UNITED STATES
NUCLEAR REGULATORY COMMISSION
WASHINGTON, D.C. 20555-0001

SUBJECT: SALEM NUCLEAR GENERATING STATION, UNITS 1 AND 2 – STAFF
ASSESSMENT OF RESPONSE TO 10 CFR 50.54(f) INFORMATION
REQUEST – FLOOD-CAUSING MECHANISM REEVALUATION
(CAC NOS. MF3790 AND MF3791)

STAFF ASSESSMENT BY THE OFFICE OF NUCLEAR REACTOR REGULATION

SALEM GENERATING STATION, UNITS 1 AND 2

Figure 3.2-3. Precipitation Hyetograph Used in the Local Intense Precipitation Analysis (PSEG, 2014a, FHRR Figure 2.1-2)

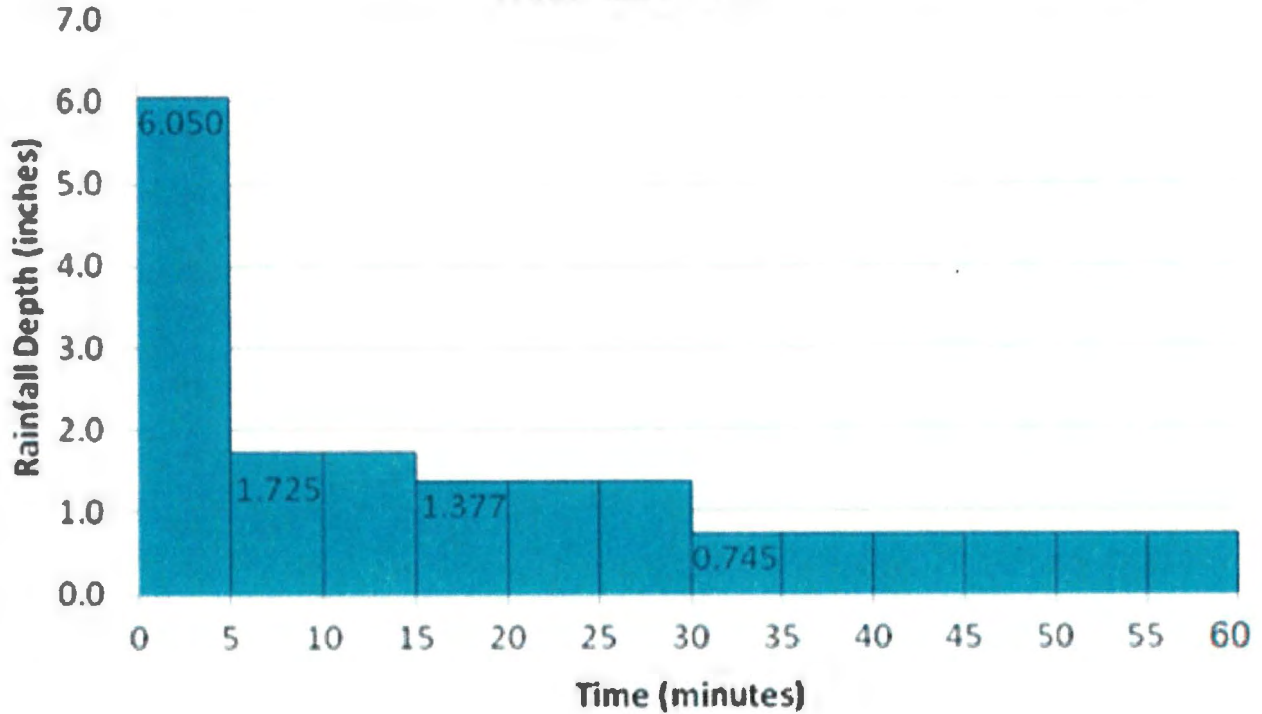
The licensee stated that the PMP precipitation hyetograph, shown in Figure 3.2-3 was developed using the methodology described in NUREG/CR-7046 (NRC 2011e).

The licensee used 5-min increments to construct the hyetograph, with the most intense precipitation flux applied during the initial 5-min increment with the precipitation rate decreasing during successive time increments (PSEG, 2014a). The NRC staff verified that the licensee followed the example described in Appendix B of NUREG/CR-7046.
